May 23, 2013

Re: Ford's Hill Estates Definitive Subdivision
Peer Review Comments

DEEP TEST HOLE 5/20/13
FORD'S HILL ESTATES
FRAMINGHAM, MA

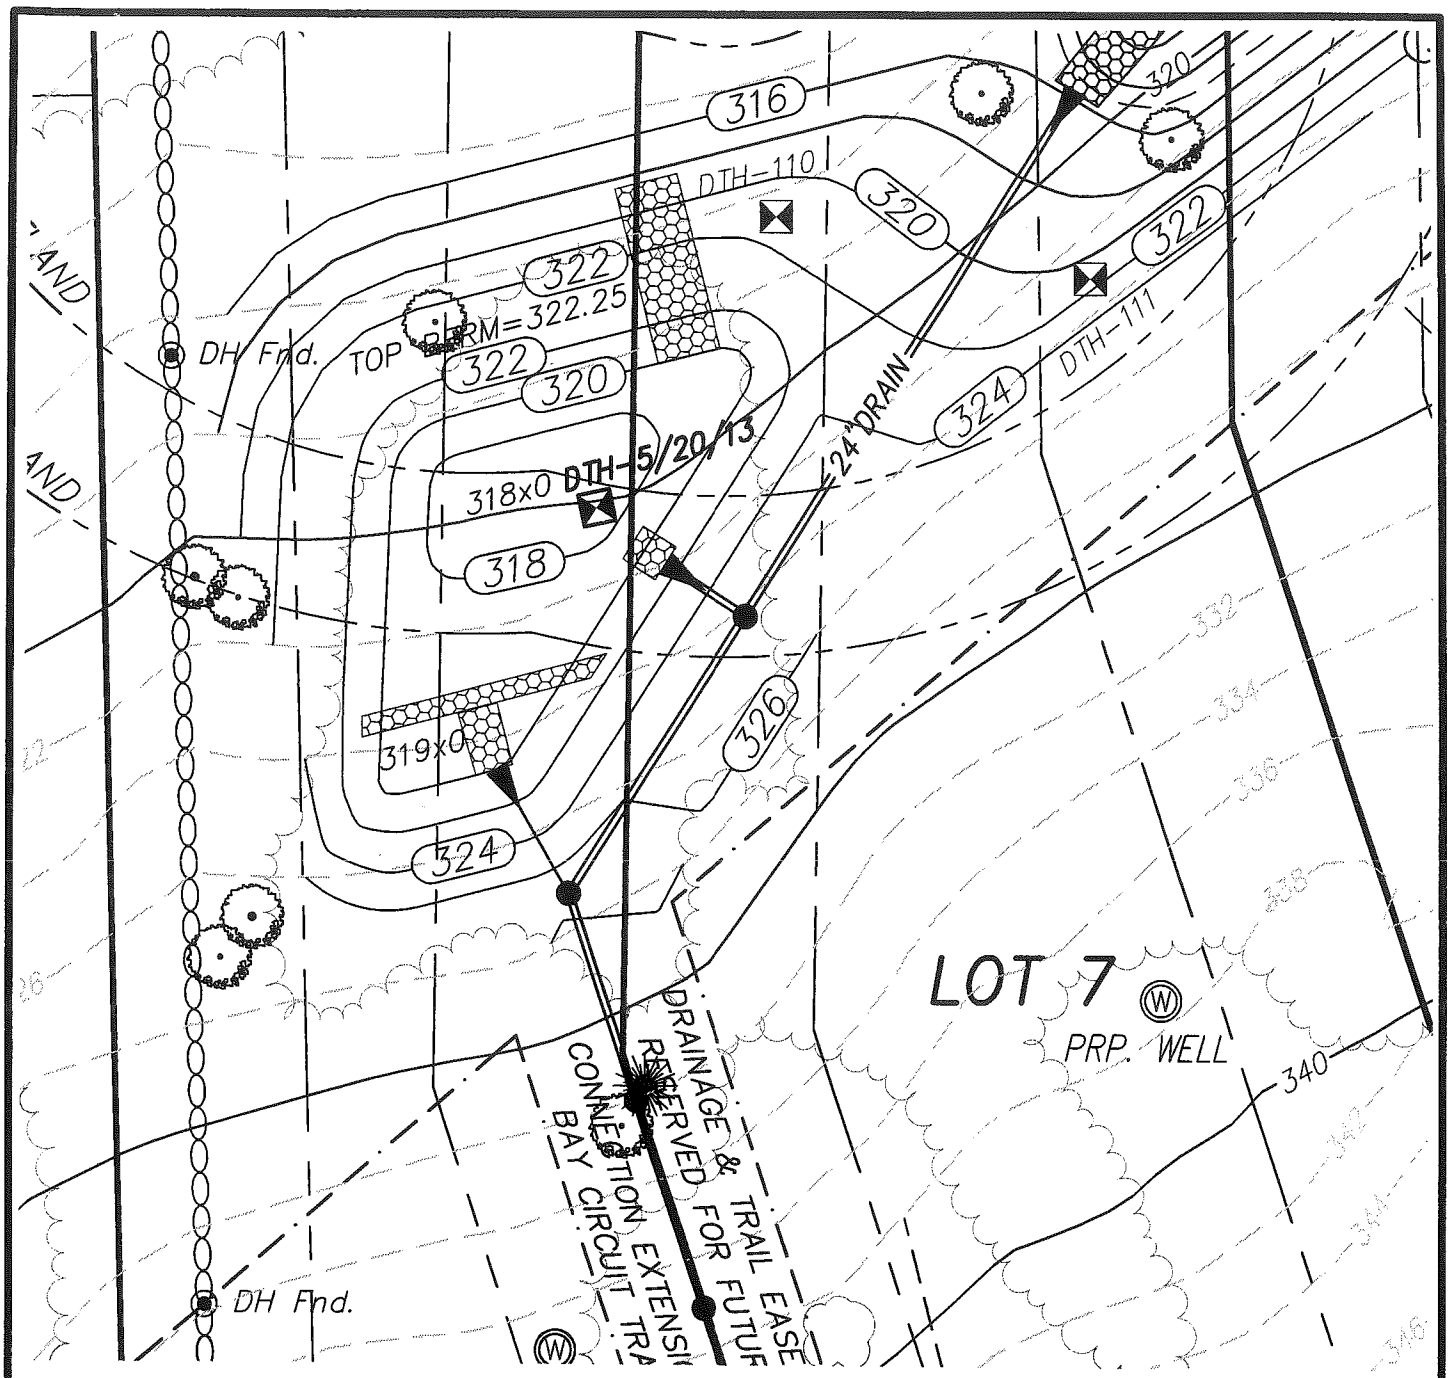
d. The requested additional soil test was performed on May 20, 2013 in the central location of the infiltration basin. The results have been attached.
e. The additional testing in the actual basin location show soil mottling at a depth of 78 inches and observed water at 132 inches. As requested, two methods for determining estimated seasonal high groundwater (ESHGW) were utilized. Soil mottling shows ESHGW at 78 inches, and groundwater adjustments utilizing the "Frimpter Method' calculate ESHGW at 85 inches. The bottom of basin is proposed at elevation 318 (24" below grade), which is greater than four feet above groundwater.

NO., DATE & ELEV.	DEPTH (In.)	SOIL HORIZON	TEXTURE (USDA)	COLOR (MUNSELL)	SOIL MOTTLING	OTHER
DTH-5/20/13 ELEV. 320	0-10"	Ap	SANDY LOAM	10YR3/3		
	10-22"	Bw	LOAMY SAND	10YR5/6		
	22-36"	C1	FINE SAND	2.5Y6/6		
	36-156"	C2	COARSE SAND/GRAVEL		78"	NO REFUSAL WATER @ 132"

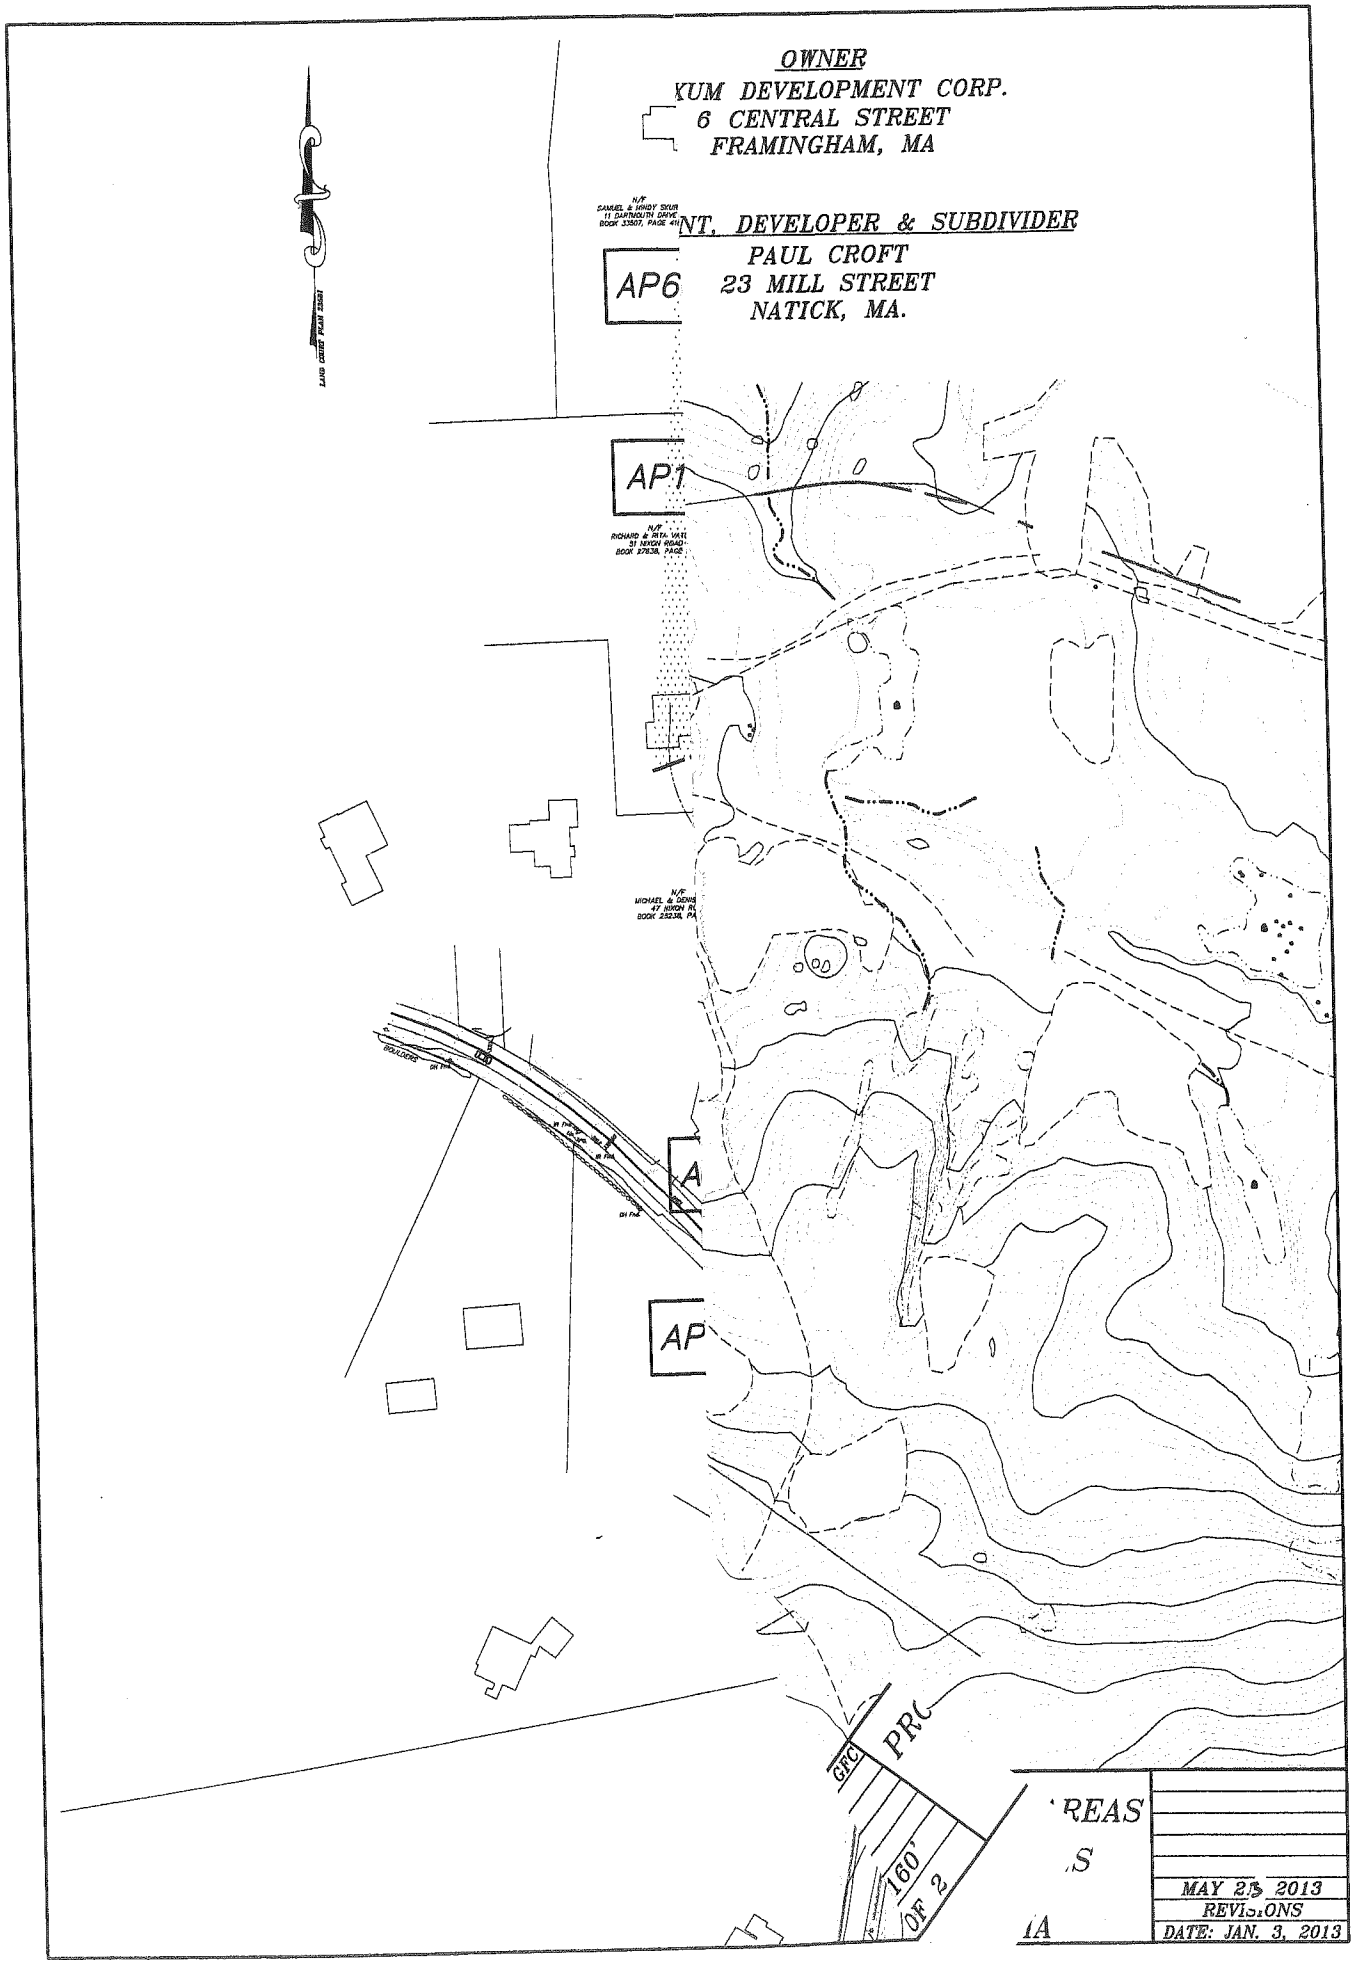
b. The land cover areas including house locations, driveways, limit of clearing, etc. have been shown on the proposed drainage area map (see attached).
